MEMORANDUM

Re: Hecate Energy Highland 2, LLC - 35MW Landscaping Review
MC Project No. 20000800A

**RESULTS OF PROFESSIONAL GLARE STUDY
35MW Photovoltaic (Solar) Project in Highland County, OH
MC Proposal No. 20000800A**

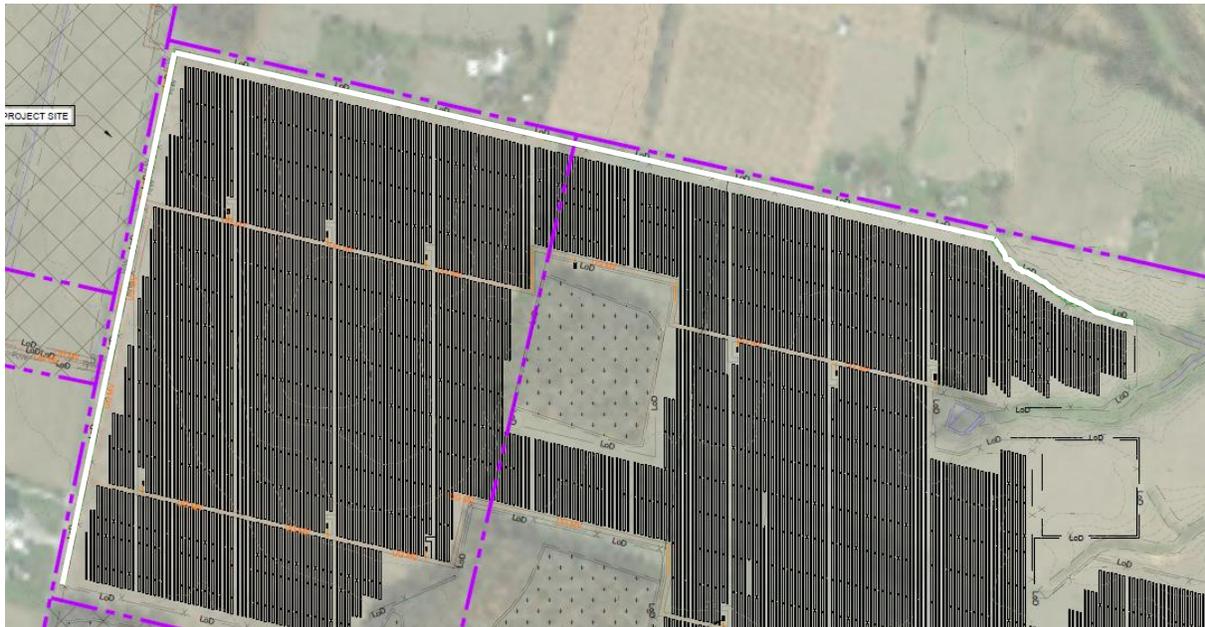
In the results of a comprehensive glare study provided to Hecate Energy by Maser Consulting, it was recommended that the owner/developer look into additional screening along Stringtown Road (Route 60) to the west and Edwards Road (Route 56) to the north of the PV project in order to provide suitable concealment of the project site and mitigate any predicted glare on any observations points and/or routes in those areas highlighted with a yellow line below.

A comparison of the results of the aforementioned glare study and the latest proposed landscaping plan provided to Maser Consulting by Hecate Energy for review (below) shows that the areas of predicted glare will likely be completely mitigated by the proposed addition of the lines of screening indicated by areas marked with WHITE in between the PV array itself and the limits of the project area.

PV ARRAY 12 RECOMMENDATION

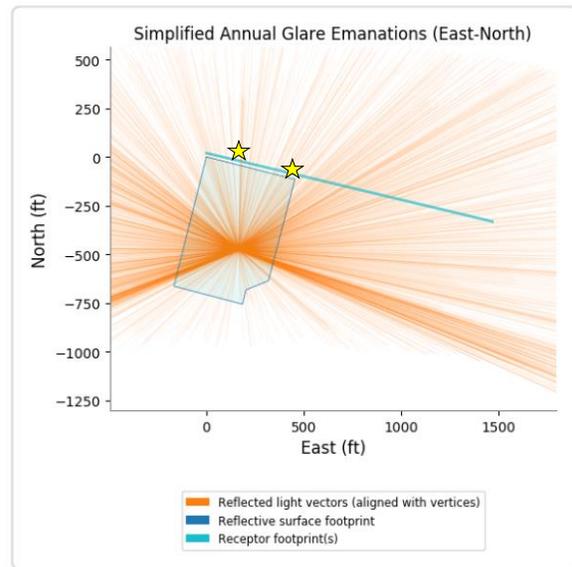
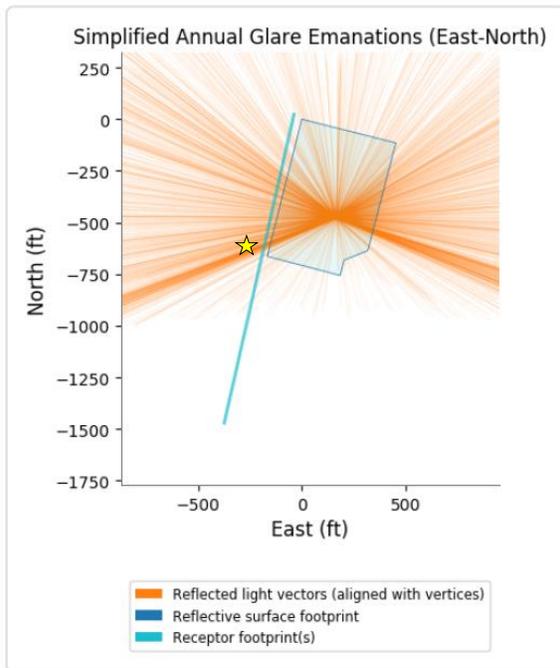
Study points and routes are very close to the array so distance will not help to mitigate the predicted glare. No marked visible natural obstructions shown on available Google earth images of this study area, and an examination of elevations shows that the area is relatively flat.

PV Array 12 likely does not presently have adequate natural mitigation for predicted glare.

The yellow stars represent the approximate locations of the residences closest to the Route and Array.

Residents in the homes, pedestrians and drivers traveling through this predicted area of glare would likely be impacted.

It is suggested that the owner/developer look into additional screening along Stringtown Road (Route 60) to the west and Edwards Road (Route 56) to the north of PV Array 12 in order to provide suitable concealment of the project site and mitigate predicted glare at Observation Point 21 and along the Routes 8 and 9.

PV ARRAY 13
OP34 / OP35 / OP36

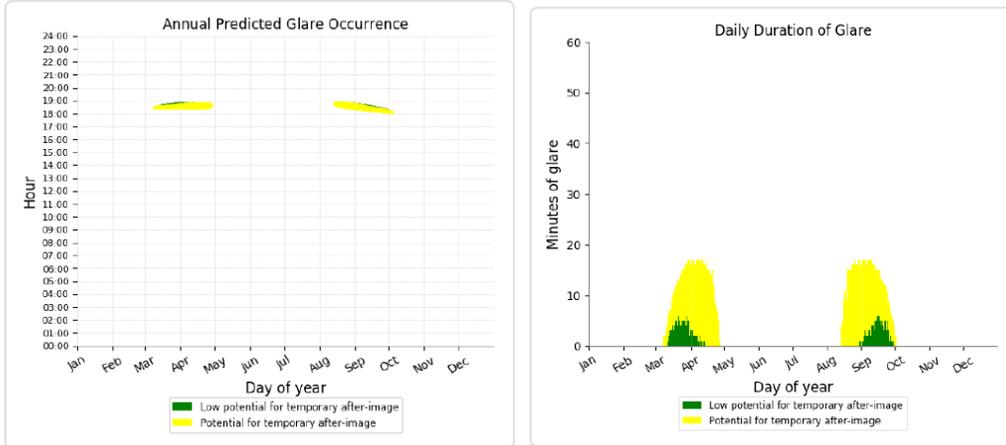
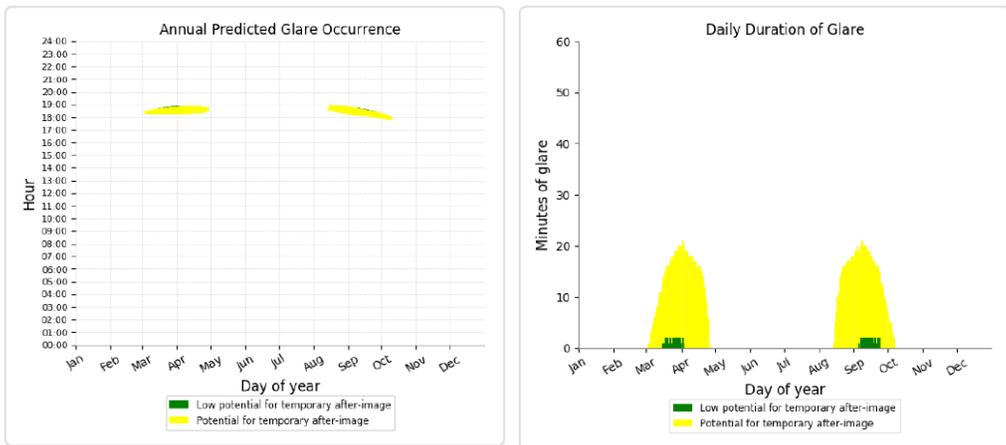
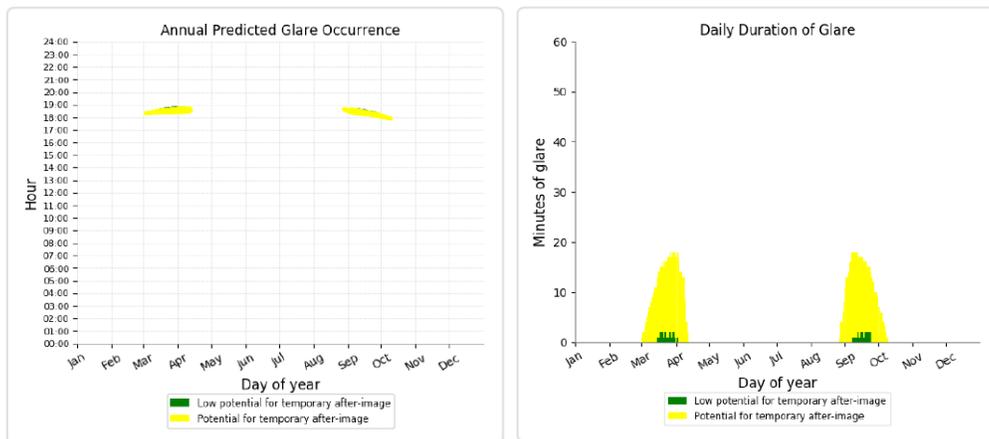
GREEN and low-grade YELLOW glare is predicted in the evening between the hours of 6 PM and 7 PM* at Observation Points 34, 35, and 36 both from the 5.5 and 15 foot heights for a few minutes up to approximately 20 minutes per day from early-March through late-April and then again from mid-August until early-October.

While high levels and/or long periods of glare are not predicted, these points do represent what look to be private residences directly across the road from the project site. The distance from the arrays and residences and negligible elevation changes are likely not enough to screen the project site from view as there is little naturally occurring foliage at most of the observation points studied.

It is suggested that the owner/developer look into additional screening along Edwards Road (Route 56) to the north of PV Array 13 in order to provide suitable concealment of the project site and mitigate predicted glare at Observation Points 34, 35, and 36. Although no model scenario predicted glare along the Route in question, any landscaping for these residence would also work to effectively screen the route for drivers.
